APPLICABILITY: 2017-19MY Impreza / Halogen Head Lamps

NUMBER: WRG-22

SUBJECT: Halogen Headlamp Low Beam & Side Reflector

WRG-22 /INTERIM SERVICE PROCEDURE INFORMATION (OFFICIAL SERVICE BULLETIN PENDING)

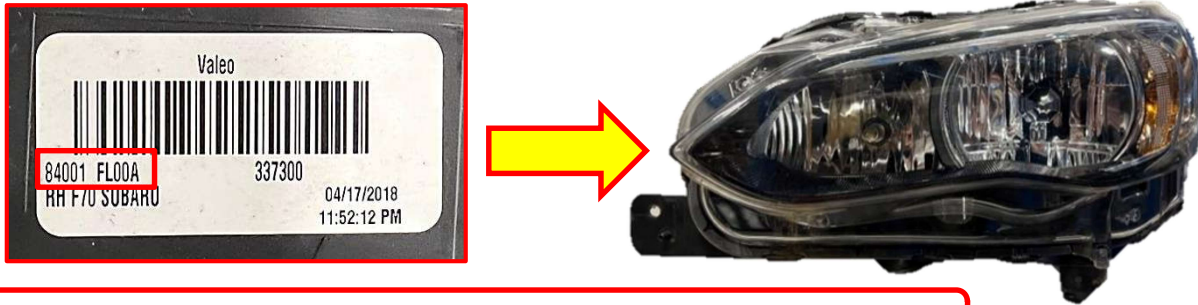
HEADLAMP INSPECTION: Locate the part numbers labeled on the both the left and right headlamp assemblies. The part identification label is located on the inner front portion of the headlamp. See the images below.

The example part identification label pictured above shows part number **84001FL00A**

Headlamps with part number **84001FL00B** or **84001FL01B** will not require replacement and can be reinstalled and adjusted. ALL other part numbers will require replacement and adjustment.
